Department of Nuclear Engineering

Docket No. 50-059

**SUBJECT: RESPONSE TO "TEXAS A&M UNIVERSITY AEROJET GENERAL NUCLEONICS MODEL 201-MODIFIED REACTOR CONFIRMATORY ACTION LETTER REGARDING SHUTDOWN RELATED TO REACTOR SAFETY SYSTEM."**

**Figure 1.1: Channel 2 Functional Block Diagram**

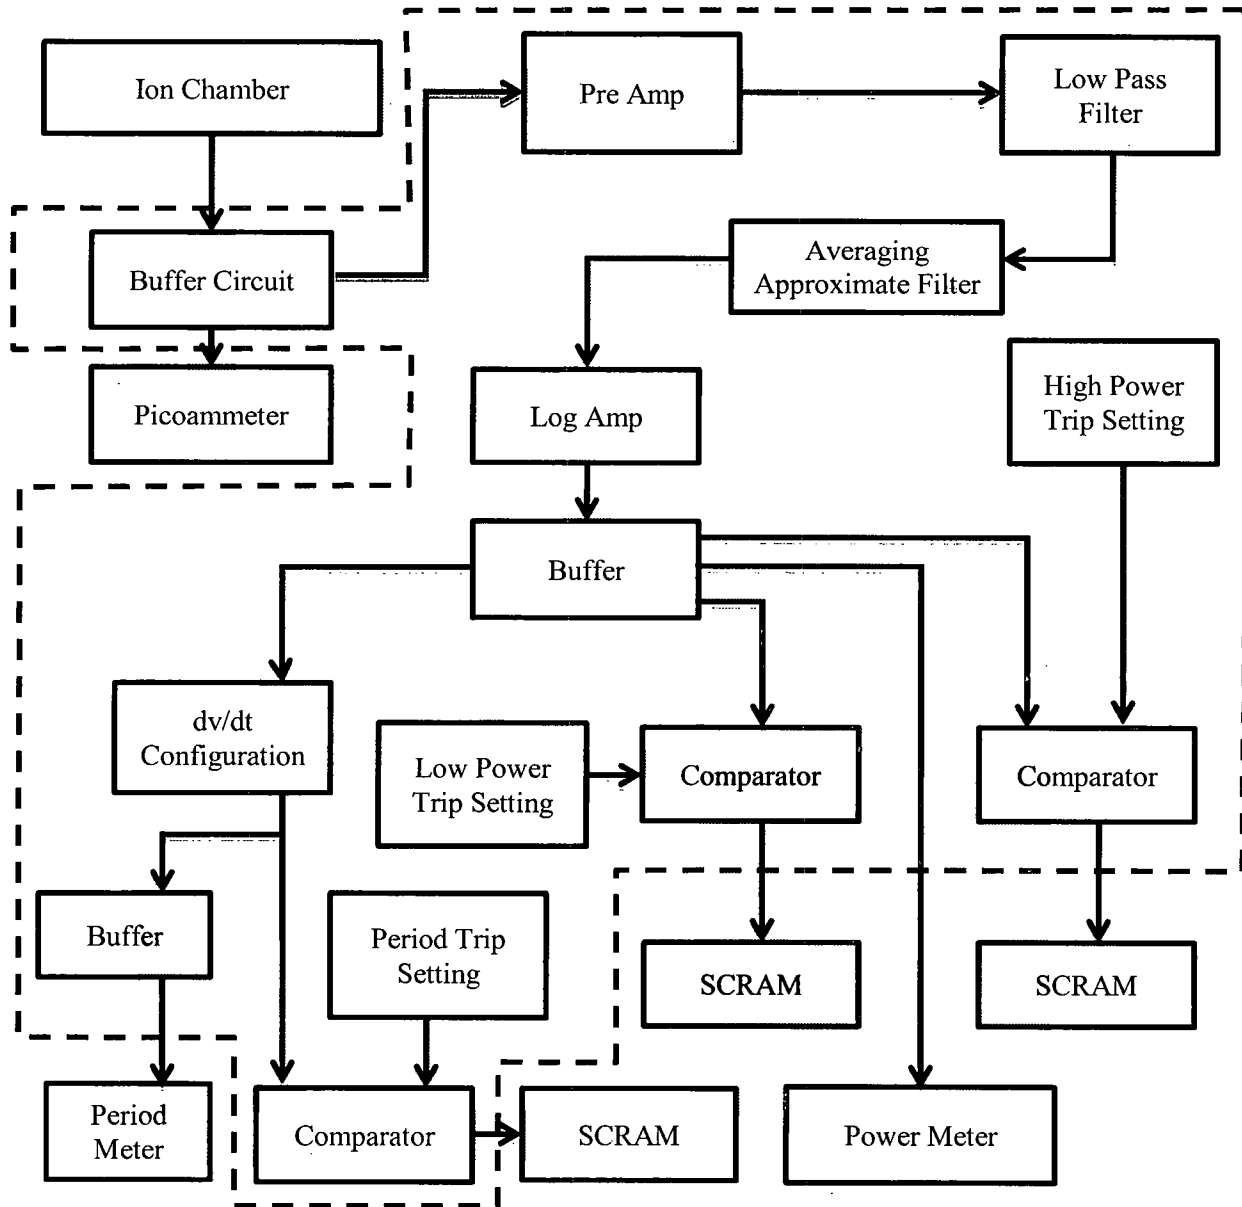
The proposed analog circuit is outlined in the functional block diagram presented in Figure 1.1. The portion of the figure enclosed by the dashed line indicates the proposed analog portions of the log channel including appropriate inputs to the reactor safety system. The portions outside the dashed box represent existing equipment. The log channel ion chamber output signal is received by the buffer circuit. This buffer circuit will utilize an op-amp buffer to replicate the input signal and provide independent outputs to the analog and digital portions of the log channel. The buffer circuit will also act as a current follower to ensure the digital and analog portions of the system are isolated from one another. The analog output is sent to the pre-amp where the incoming signal is amplified before it is passed to the low pass filter. The low pass filter removes high frequency noise, including common 60 Hz interference. This filtered signal is passed to the averaging approximate filter to create a moving average approximation. The following equation will be used to implement this filter:

This signal will then be used to calculate the reactor period, provide input to the reactor protection system, and display reactor power level. The reactor period will be calculated by using a derivative configuration and use the following equation:

The output of the derivative is 180° out of phase; therefore, an analog inverter has been included in the configuration. The output signal of the log amplifier will also be sent to a high and low power comparator to determine if a safety shutdown should occur given the input. If this value meets or exceeds a safety set point, a scram signal is generated and sent to the scram circuit and alarm panel, initiating a protective action resulting in power interruption to the electro-magnets and the corresponding alarm light illumination. The log amplifier also drives indication of reactor power while the derivative function provides input to reactor period indication.

The new hybrid log channel will be composed of a digital interface used solely as an operator aid and will provide no contribution to the reactor protection system. The other portion of the log channel will be an analog circuit providing input to the reactor protection system in accordance with Appendix A to License No. R-23, section 3.2.

**Figure 1.2: Channel 3 Functional Block Diagram**

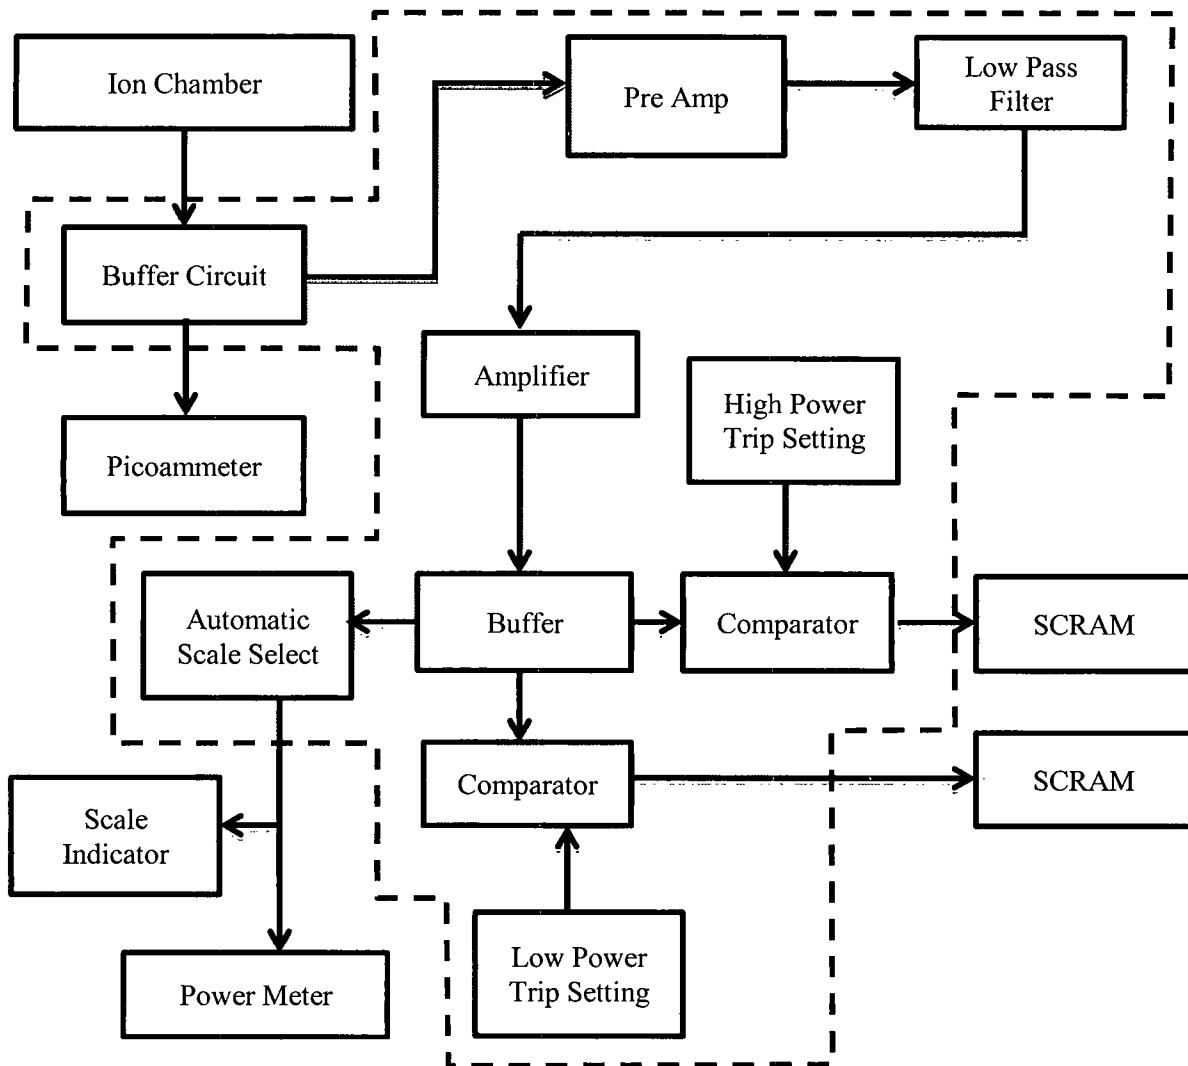
The proposed analog circuit is outlined in the functional block diagram presented in Figure 1.2. The portion of the figure enclosed by the dashed box indicates the proposed analog portions of the linear channel including appropriate inputs to the reactor safety system. The portions outside the dashed box represent existing equipment. The linear channel ion chamber output signal is received by the buffer circuit. This buffer circuit will utilize an op-amp buffer to replicate the input signal and provide independent outputs to the analog and digital portions of the linear channel. The buffer circuit will also act as a current follower to ensure the digital and analog portions of the system are isolated from one another. The analog output is sent to the pre-amp where the incoming signal is amplified before it is passed to the low pass filter. The low pass filter removes high frequency noise, including common 60 Hz interference. The filtered signal is amplified to increase the gain for further processing. The output signal of the amplifier is sent to a high and low power comparator to determine if a safety shutdown should occur given the input. If this value meets or exceeds a safety set point, a scram signal is generated and sent to the scram circuit and alarm panel, initiating a protective action resulting in power interruption to the electro-magnets and the corresponding alarm light illumination. The amplified signal is also passed to

the linear power meter and a scale indicator which provide visual indication of power level and decade of power.

The new hybrid linear channel will be composed of a digital interface used solely as an operator aid and provides no contribution to the reactor protection system. The other portion of the linear channel will be an analog circuit providing input to the reactor protection system in accordance with Appendix A to License No. R-23, section 3.2.

Figure 7.2.1-1: AGN Logic Diagram

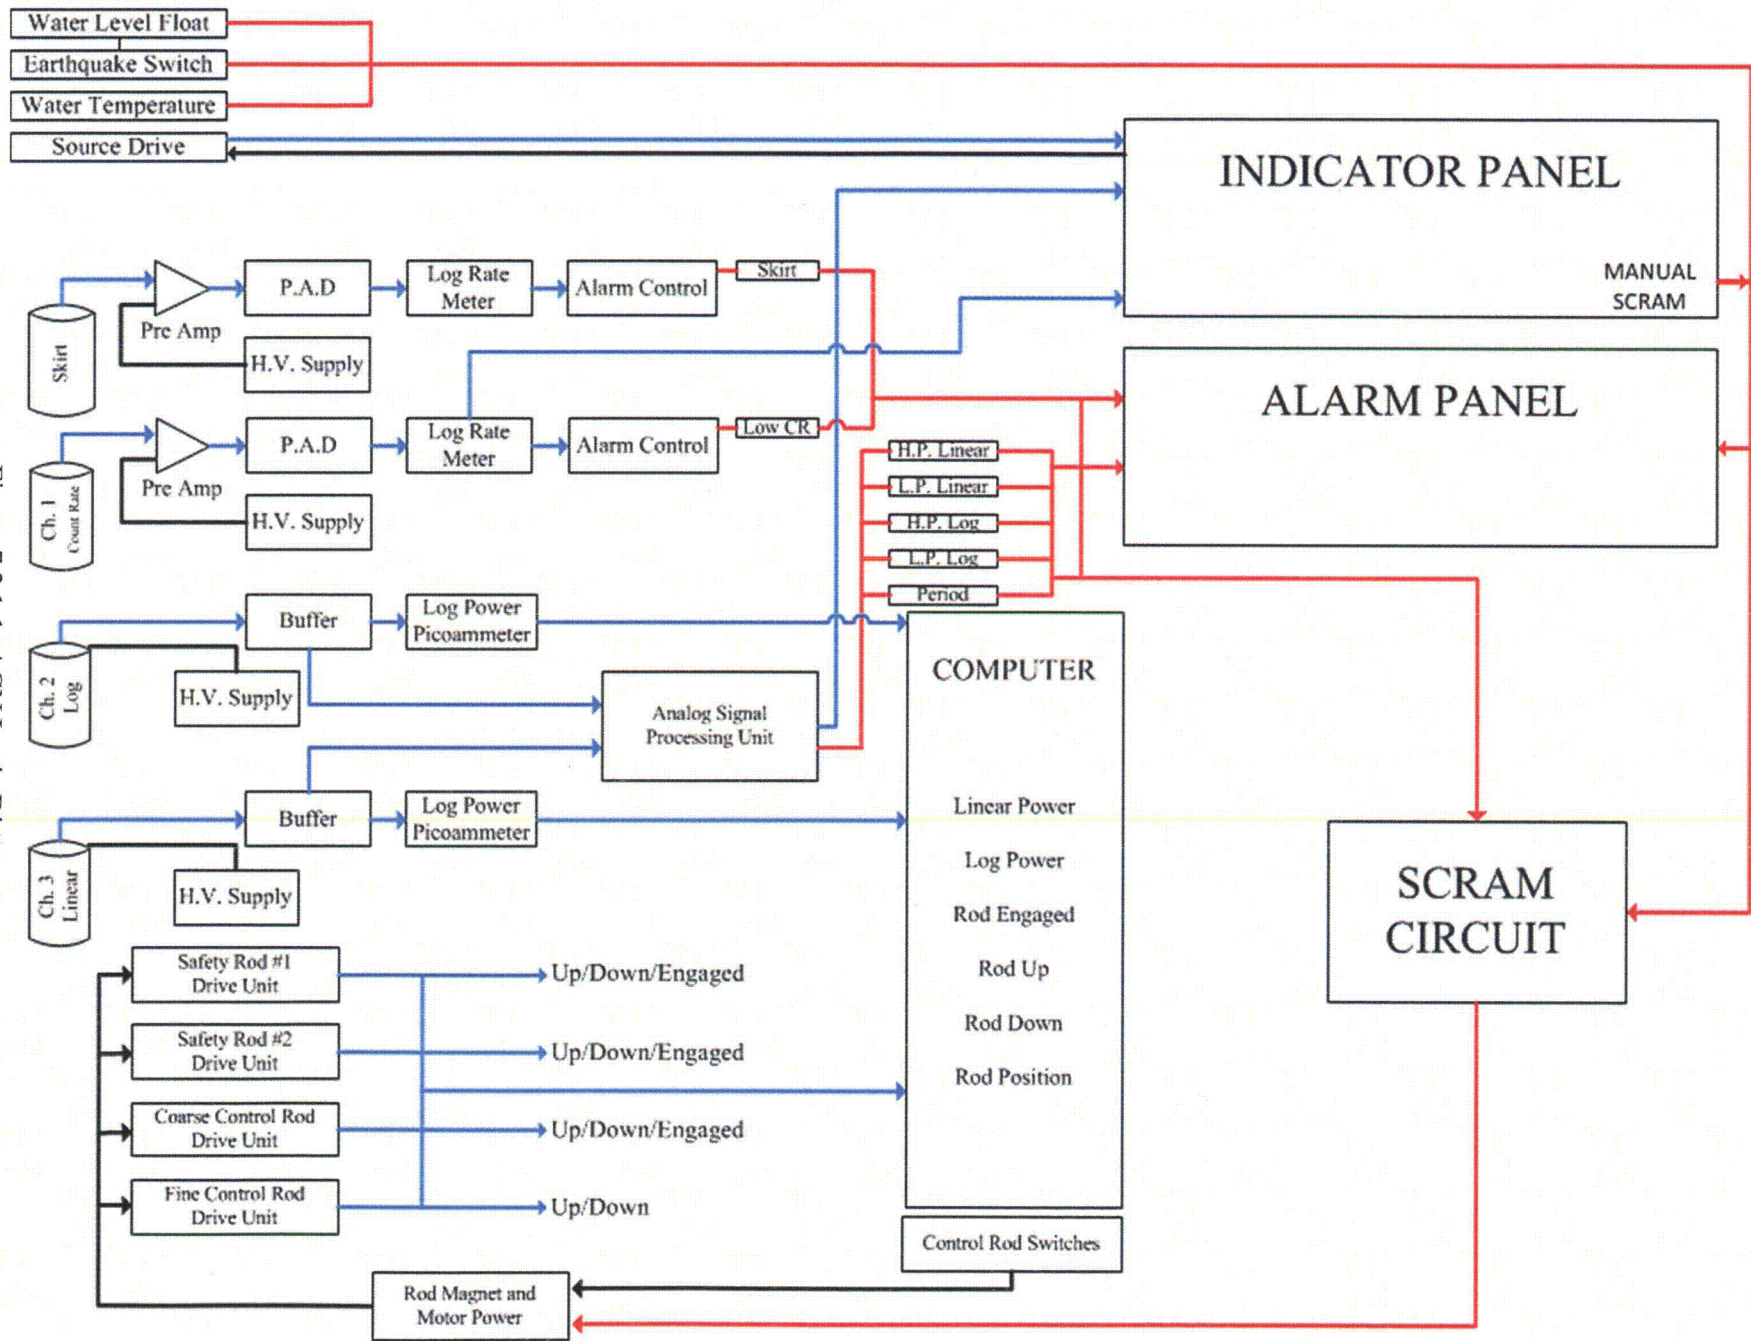
The resulting I&C system will include an analog and digital system operating in parallel. The digital portion of the system will provide an operator aid while controlling the reactor with no safety system input. The analog portion of the system will be used to provide indication of reactor power for the log and linear channels as well as perform the period calculation and indication while providing an input into the reactor protection system along with all other previous inputs to the safety system. This will restore the reactor control console to a completely analog reactor safety system. An updated logic diagram is presented in Figure 7.2.1-1.
